RESPONSE LETTER

RE: South Parker Express Car Wash
5380 S Parker Rd
Aurora, CO 80015

PRE-APPLICATION MEETING-HELD JANUARY 7, 2021

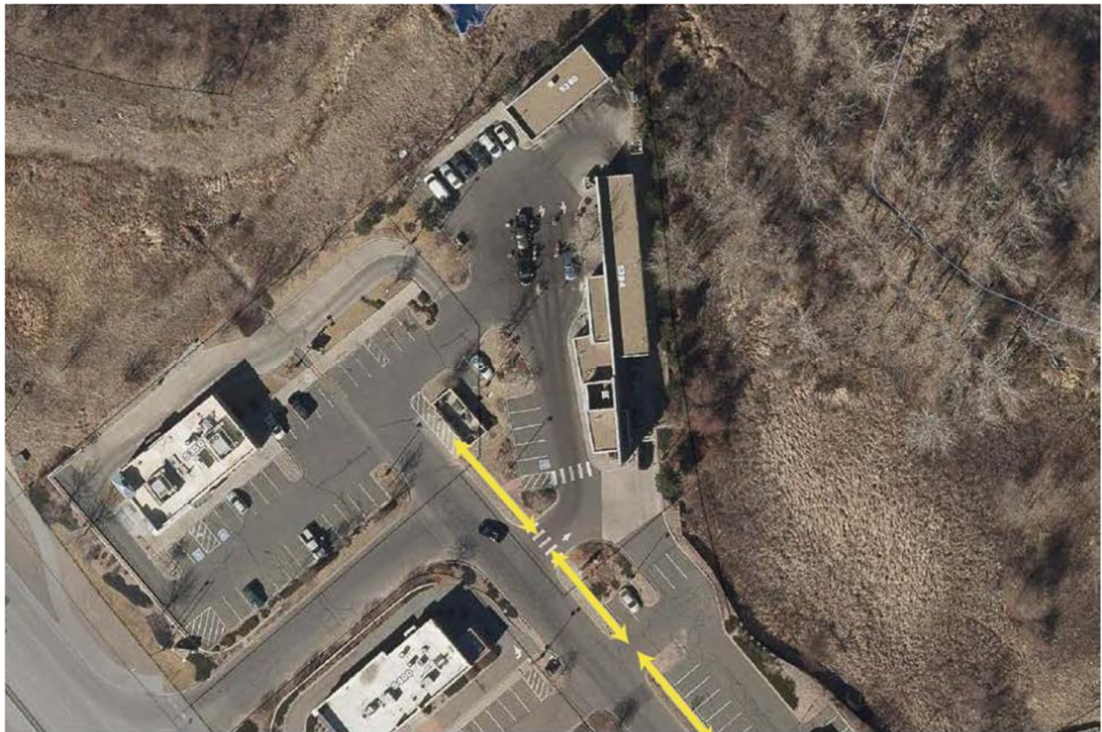
2. Maintaining pedestrian access on adjacent private road to the south. The current site conditions show existing detached sidewalks along the southern portion of the parcel. This sidewalk should be maintained to provide pedestrian connectivity through the retail development. See diagram below

RESPONSE: Sidewalk is intended to remain in new design configuration.
